Subject: Change to USCAR-37, Rev 1 Letter #3

CHANGES TO USCAR-37

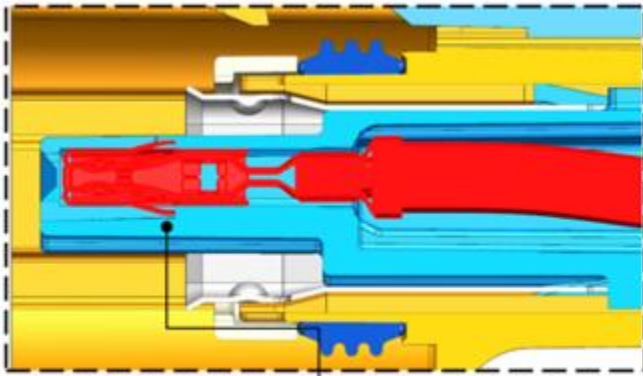
Changes have been made to USCAR-37, Rev 1 specification to change the criteria for 5.2.4.5. The change is required since terminal retention on small cables is more difficult to achieve than on large cables. Comments and questions can be sent to EWCAP@uscar.org.

5.2.4.5 is changed as shown:

* 110 N is allowed for cable sizes $\leq 5\text{mm}^2$ if ferrule is not involved in the terminal retention (as shown below).

Terminal tangs, lock finger, and independent secondary lock must provide all the terminal retention for 110N criteria to apply (i.e. ferrule cannot contribute to terminal retention).

5.2.4.5 Acceptance criteria

The minimum force required to move the ferrule from its installed position shall be $\geq 150^*$ N.
